## **REVISED**

**TO:** HEARINGS OFFICER

**SUBJECT:** **CONDITIONAL USE/CLASS 3 SITE PLAN REVIEW/CLASS 2  
DRIVEWAY APPROACH PERMIT CASE NO. CU-SPR-ADJ18-05  
4227 LONE OAK ROAD SE  
AMANDA NO. 18-106940-ZO & 18-106941-RP**

Summary: A conditional use, site plan review, and driveway approach permit application for building additions, removal of a driveway, modification of a driveway, and reconfiguration of parking areas for a religious assembly.

1 SITE PLAN

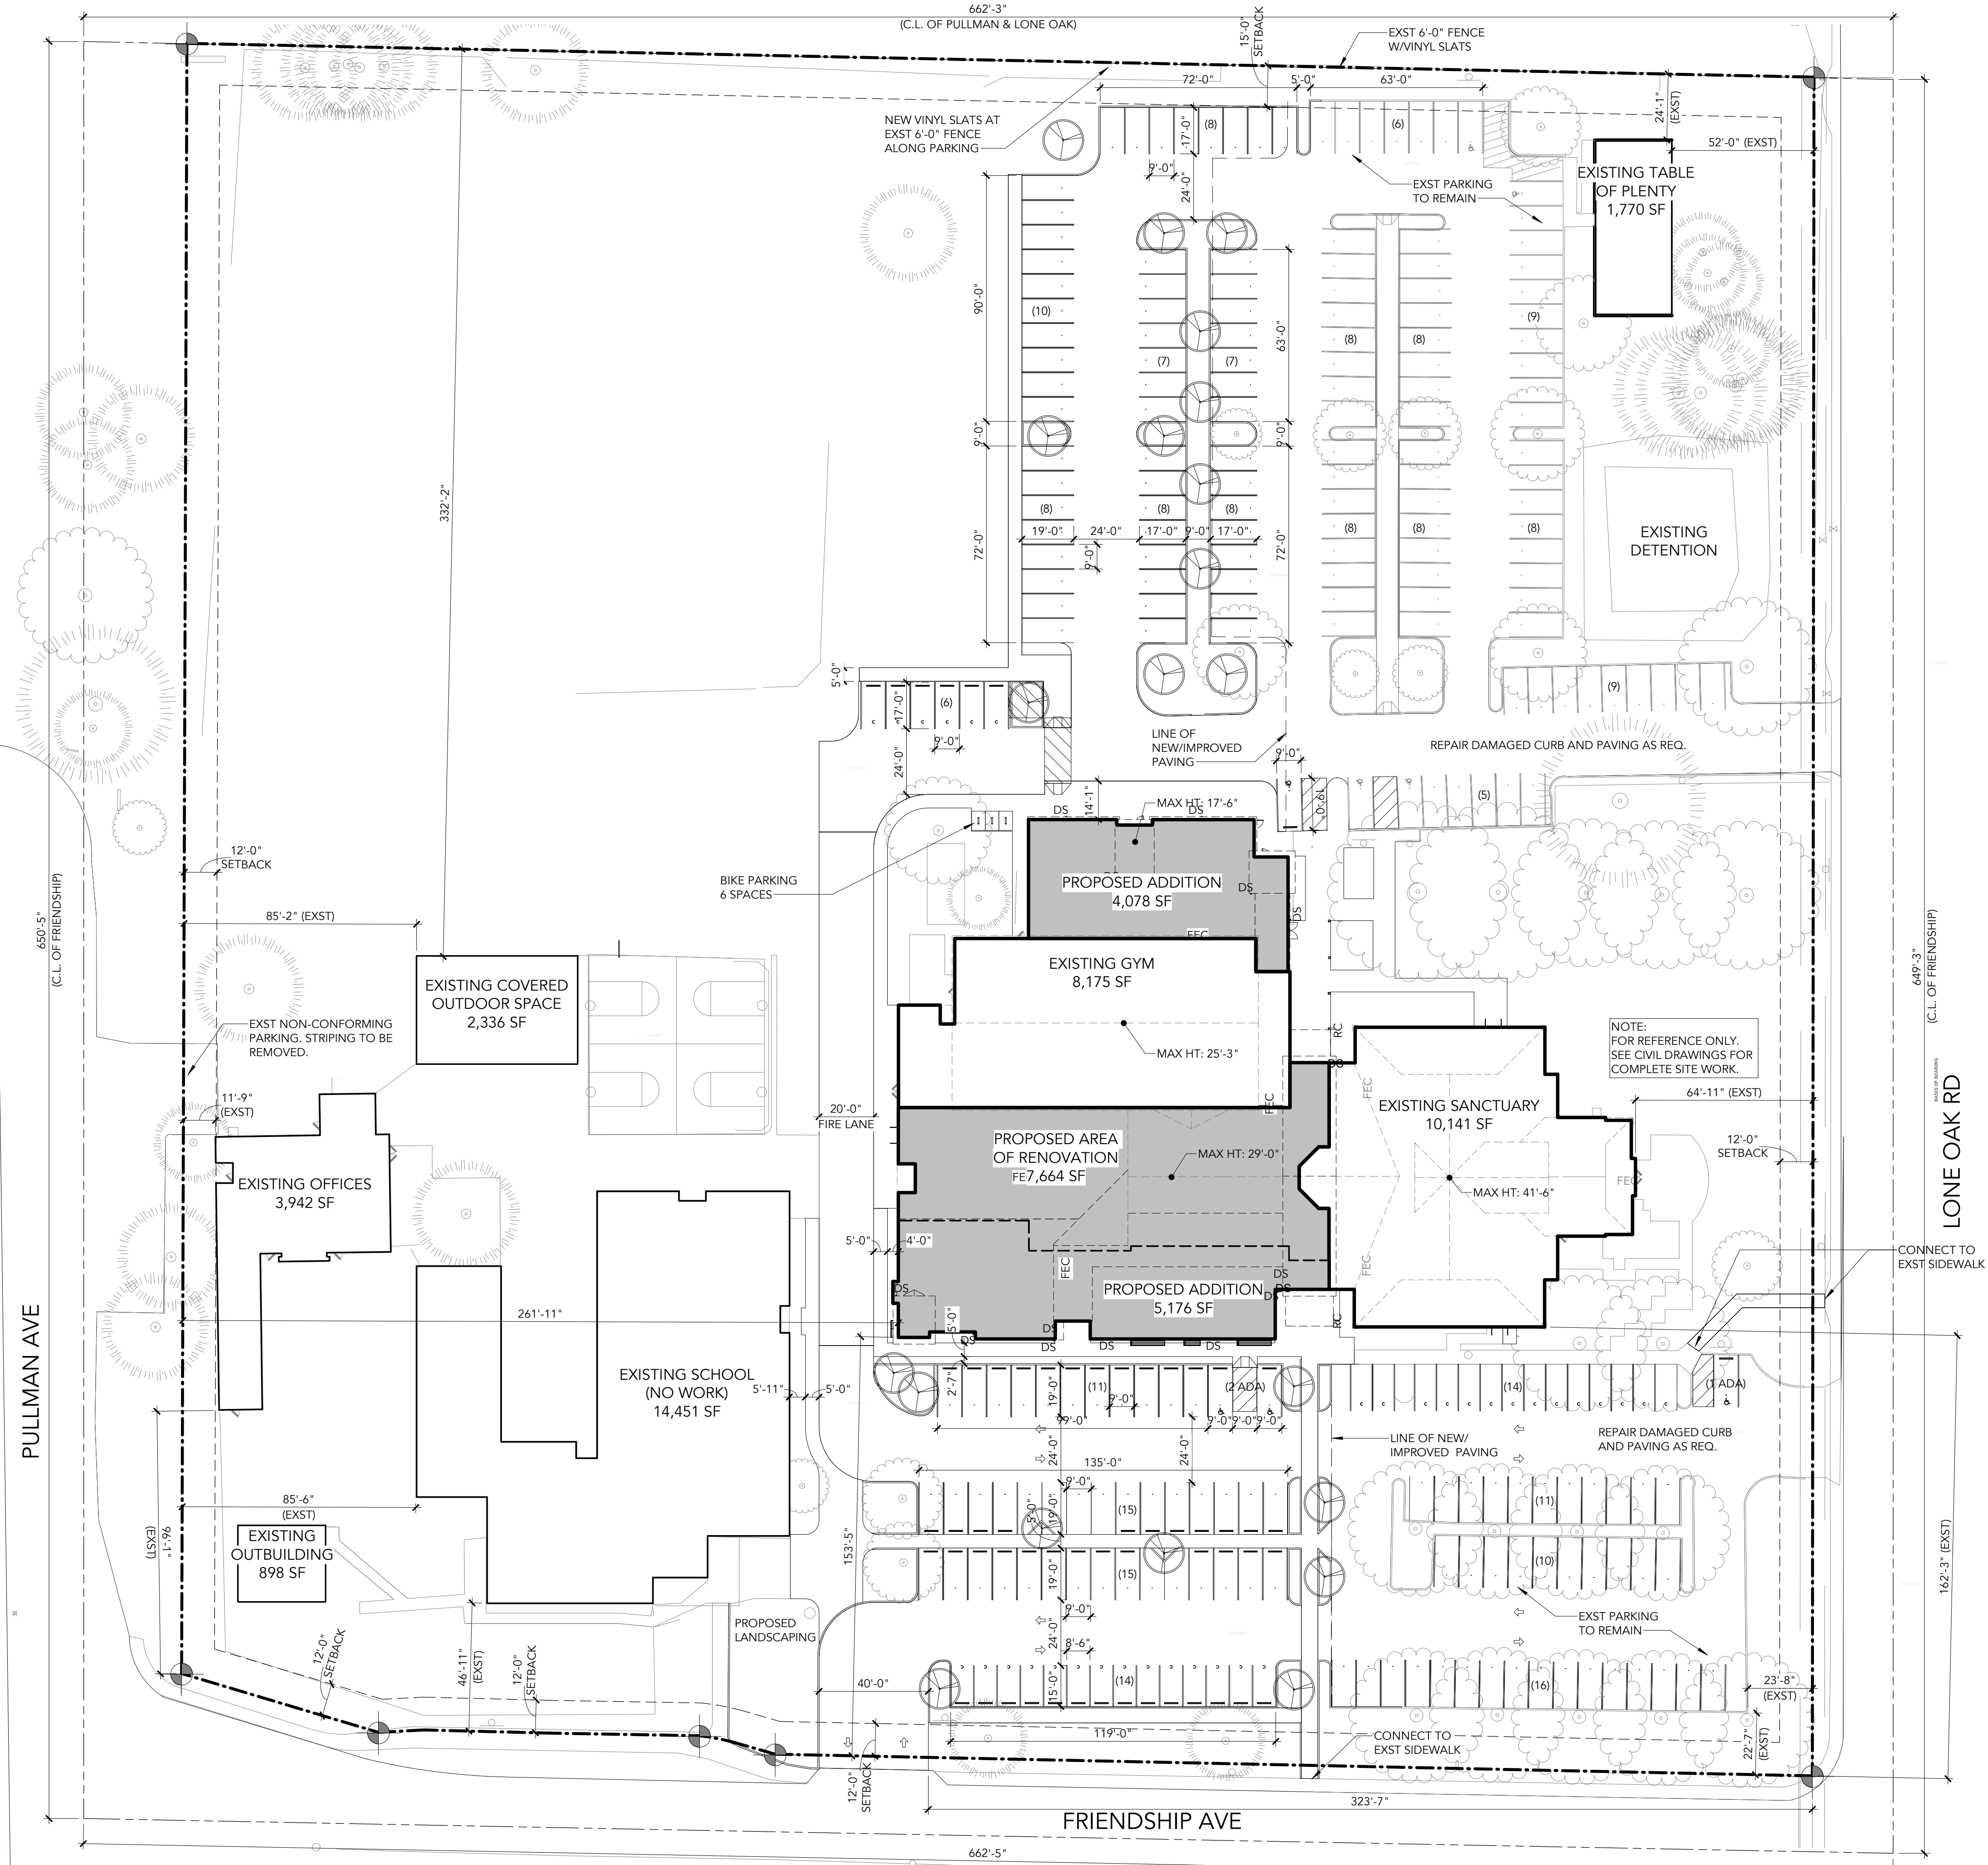
**Condition 2:** Provide a landscaped setback of at least 15 feet between the new parking lot pavement and the north property line, landscaped with a minimum of one plant unit per 20 square feet and screened with a minimum 6-foot-tall sight-obscuring fence, wall, or hedge.

**Condition 3:** Remove the proposed triangular planting areas in the reconfigured south parking lot.

**Condition 4:** The eight new parking spaces in the northern row of the expanded north parking lot shall be designated as compact spaces.

**Condition 5:** The 20-foot-wide "Fire Lane" depicted on the site plan between the north and south parking areas shall be widened to a minimum of 22 feet to accommodate two-way traffic.

**Condition 6:** Bumper guards or wheel barriers shall be installed in the eight new parking spaces in the northern row of the expanded parking lot and all of the parking spaces abutting the proposed sidewalk that is oriented east to west through the reconfigured area of the southern parking lot.
